Questions Submitted for Professional Architectural Design Services Addendum # 1

When you have a chance can you send me the spec documents for this bid?
 "RFQ - Professional Architectural Design Services for Alamo Heights Pool Park"

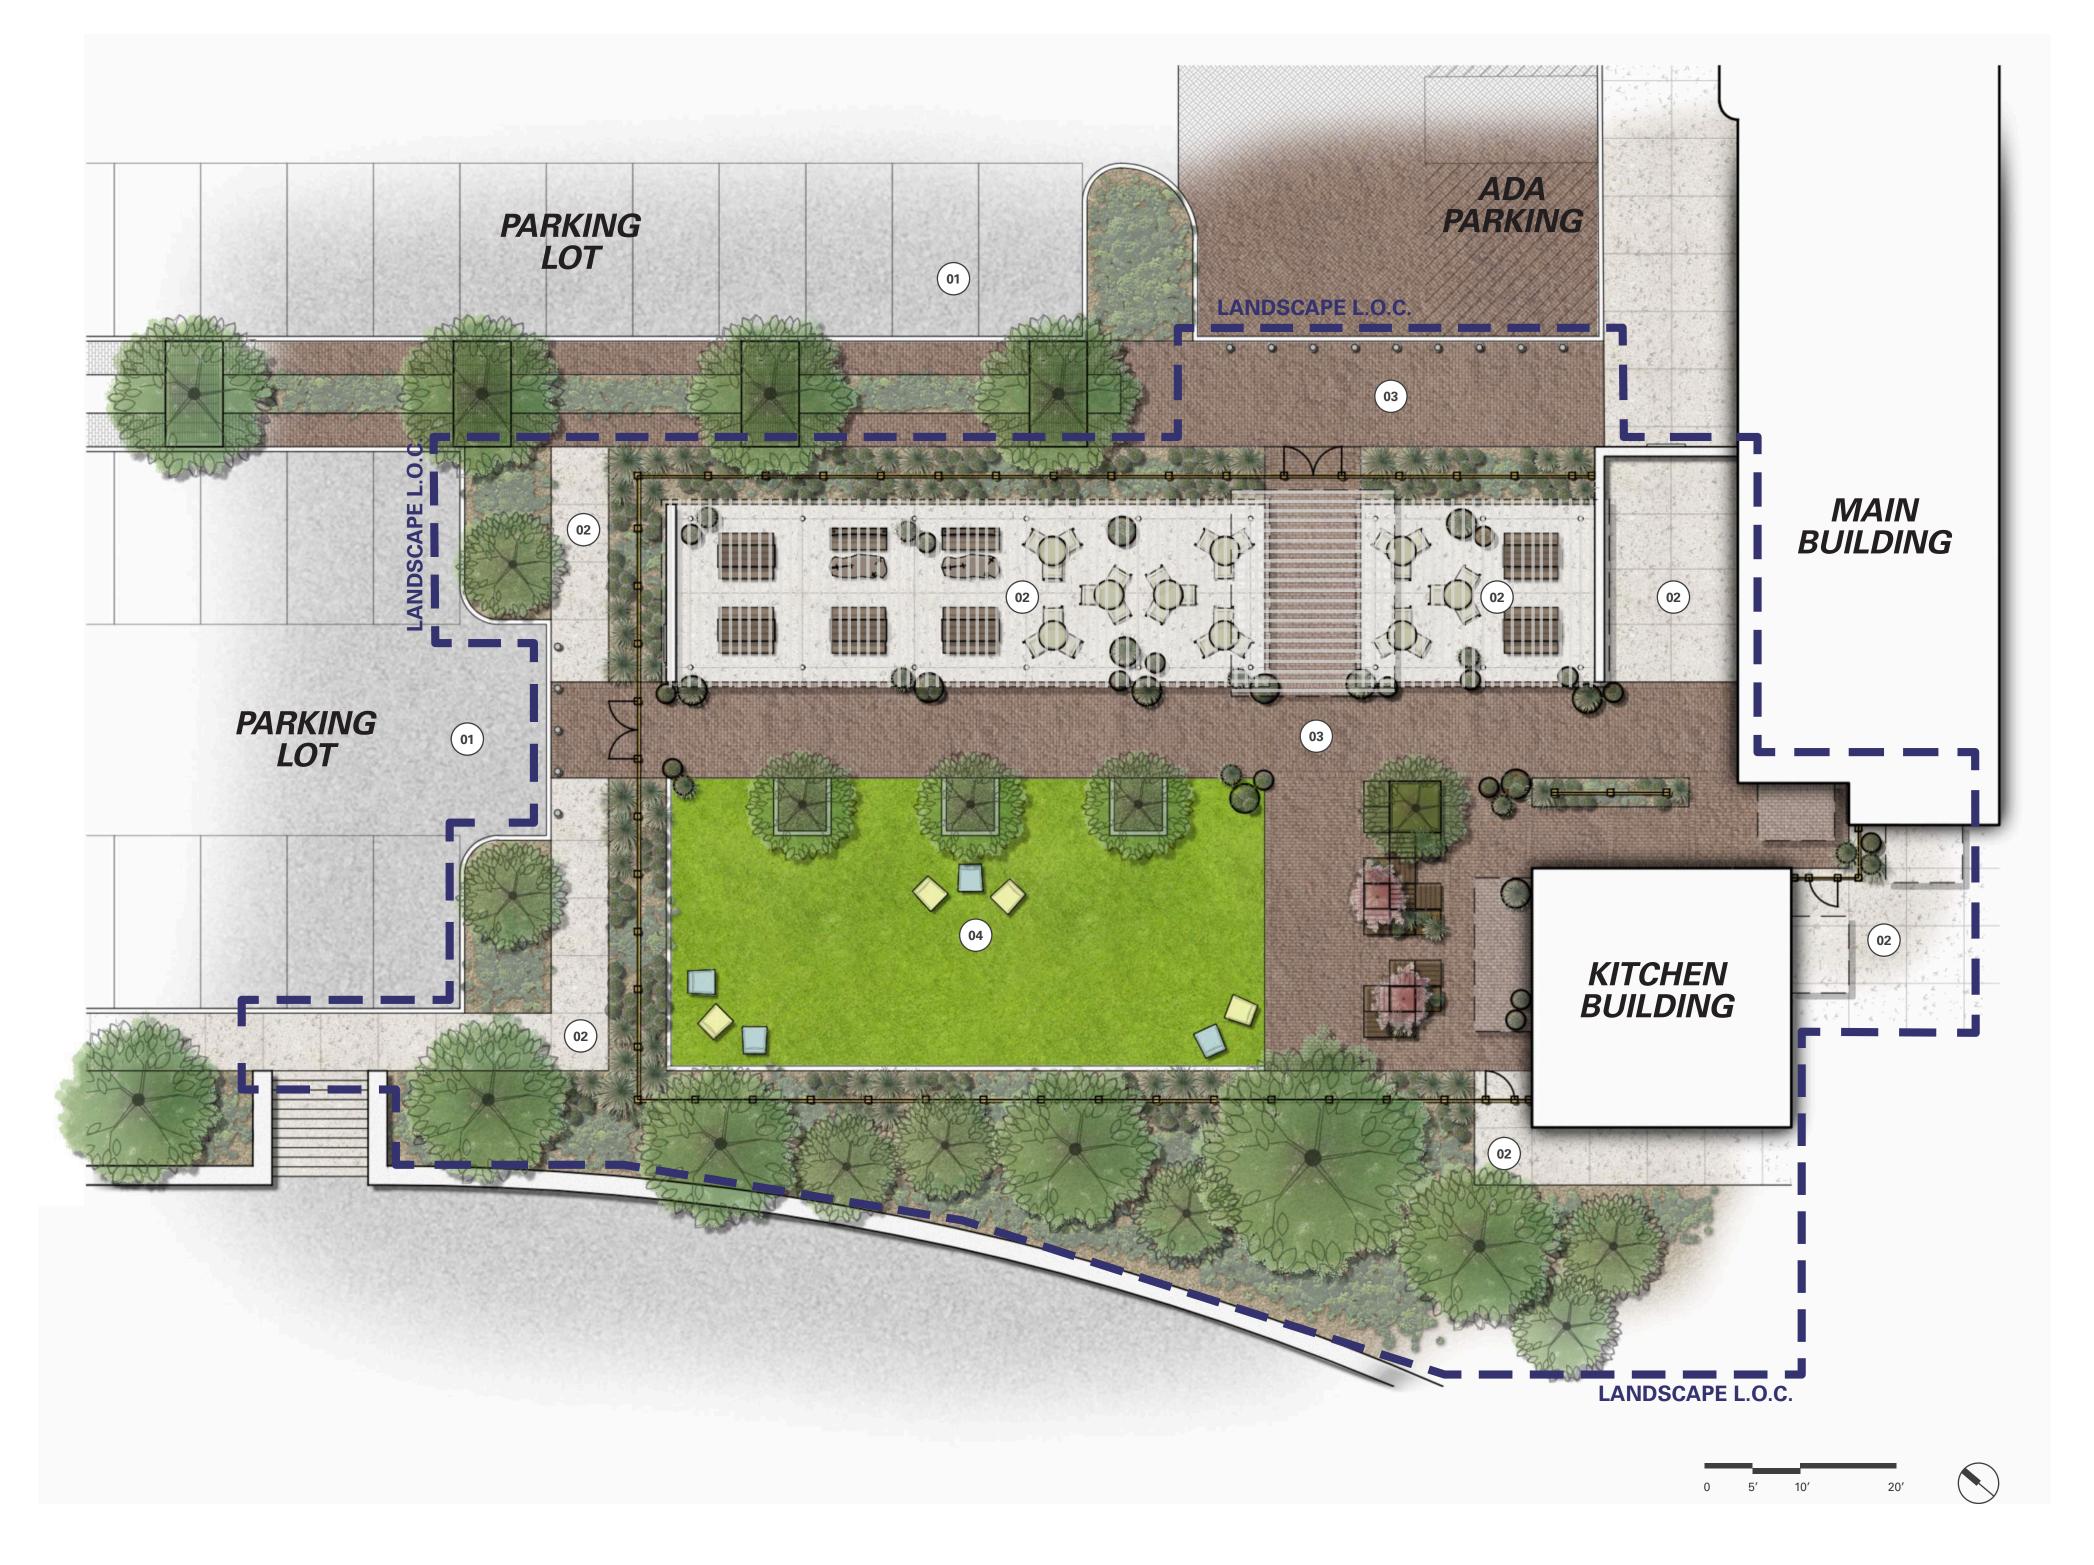
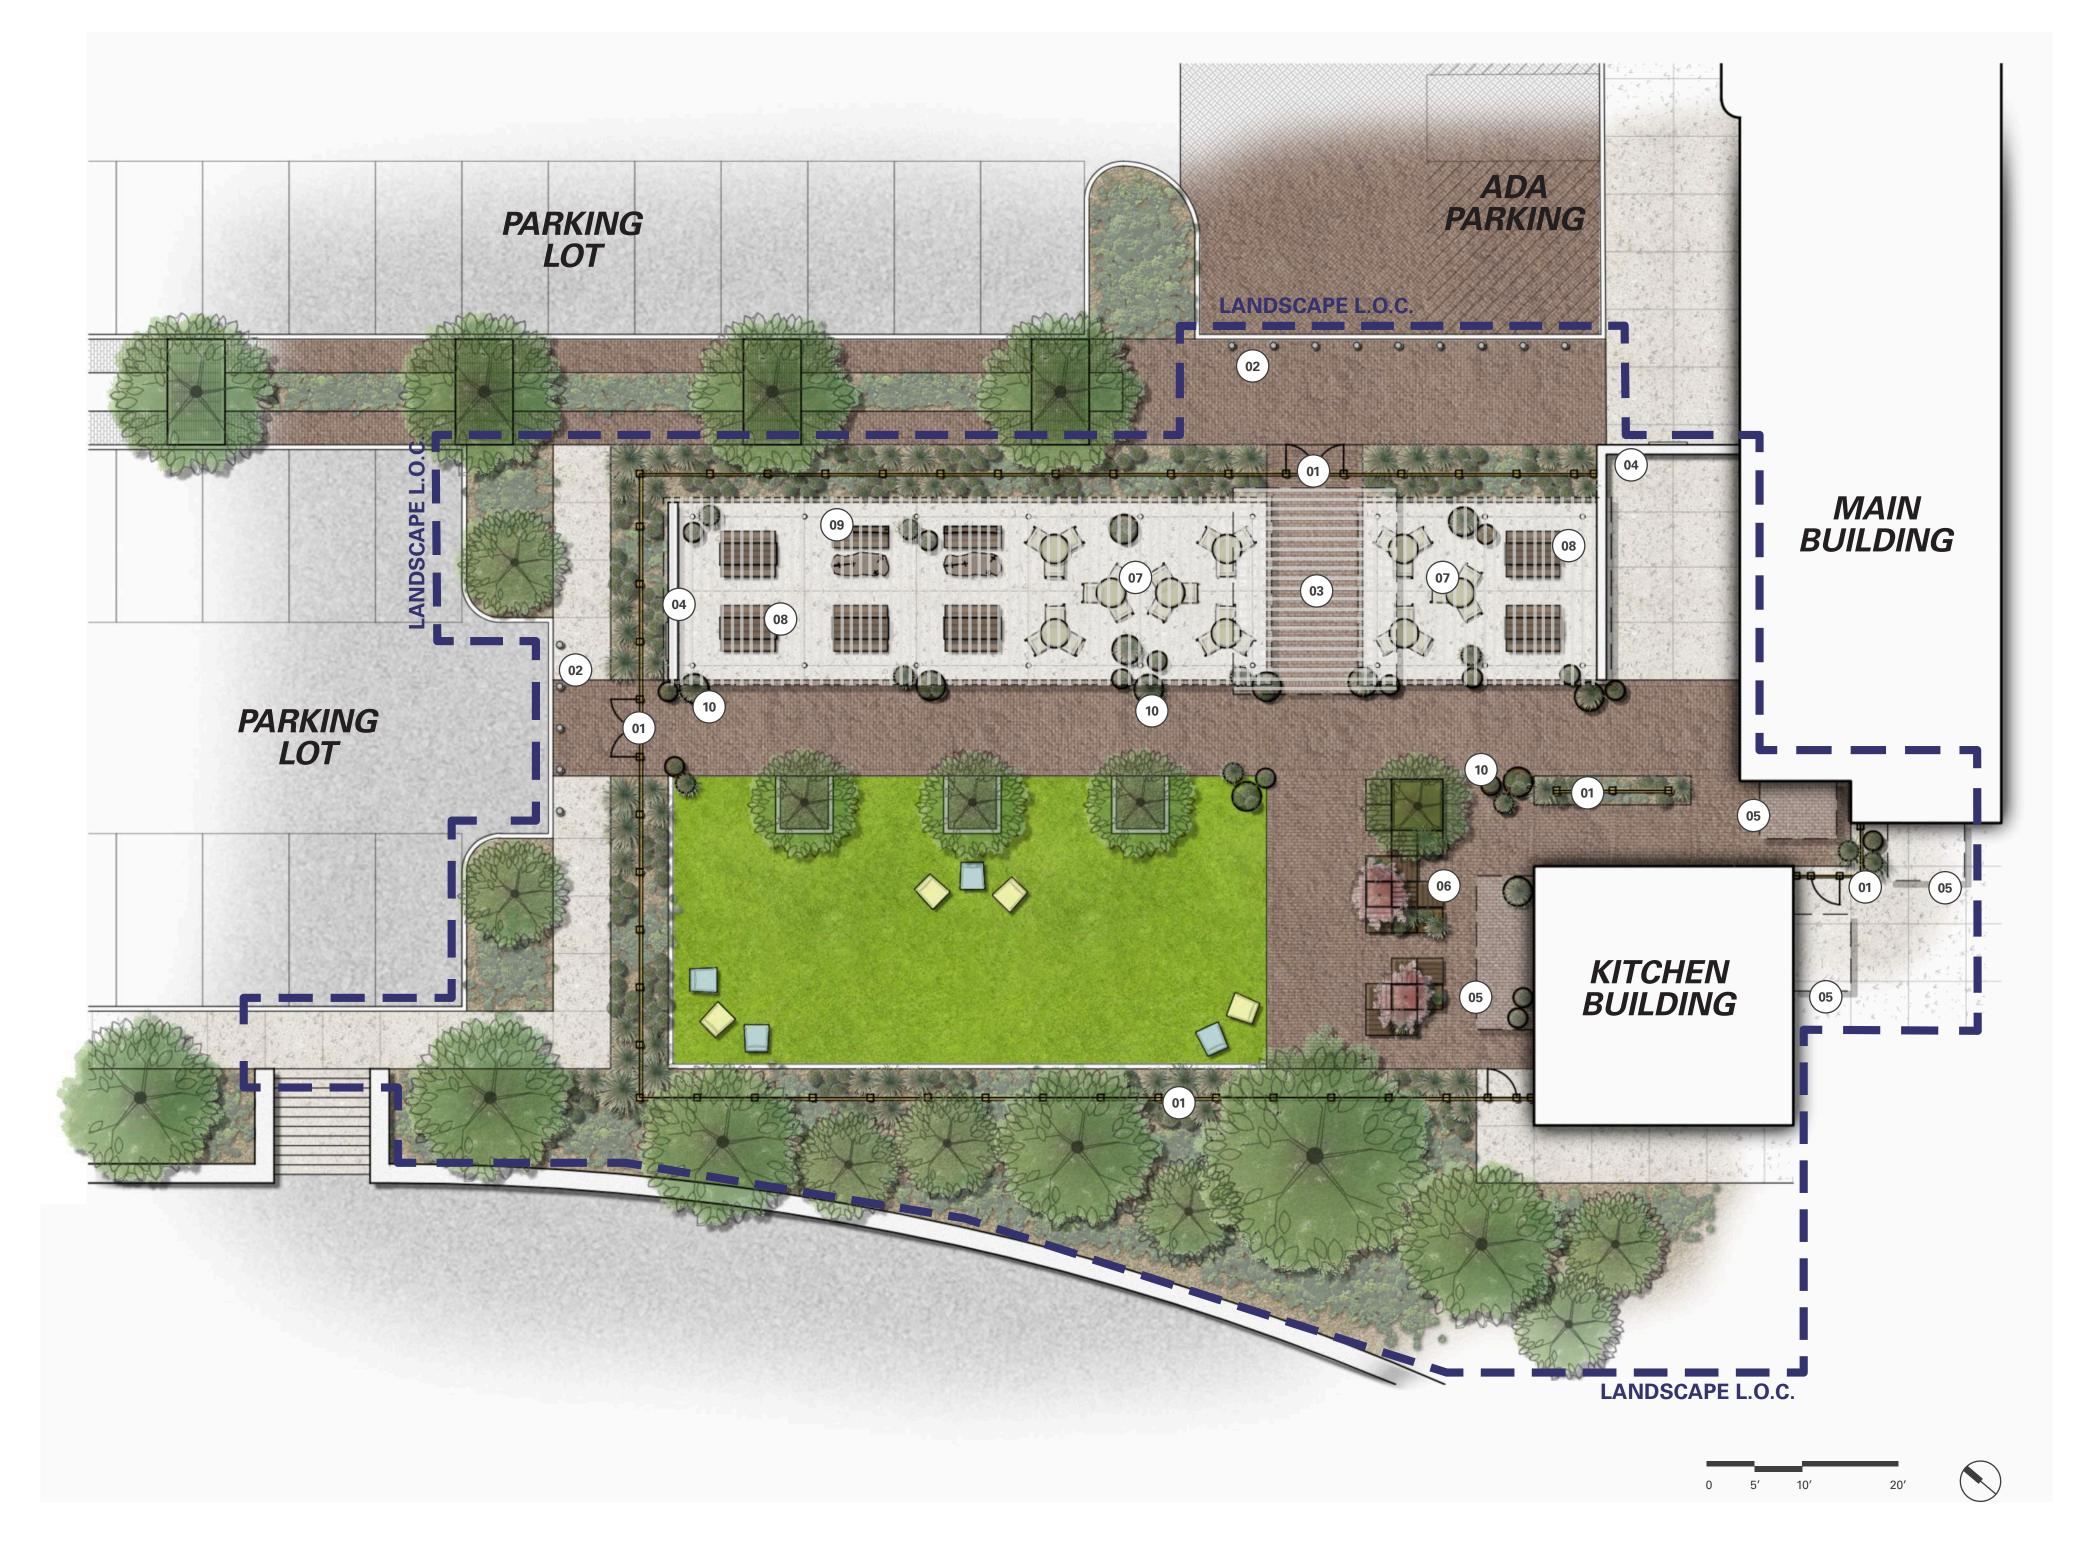
2. In the RFQ on page 6 it says, "Please reference City's Landscape Architecture Consultant's landscape exhibit for concept." I do not see the exhibit in the RFQ. Can you let me know if this is somewhere else or if it will come out in an addendum?

9. In the scope of work (#1), it states to reference City's Landscape Architecture Consultant's landscape exhibit for concept. Can this be provided?
Answer:
The Conceptual Plan is now available as Attachment 1 in this document. Please note the

The Conceptual Plan is now available as Attachment 1 in this document. Please note the Conceptual Plan is for preliminary reference only.

Conceptual Plan is for preliminary reference only.
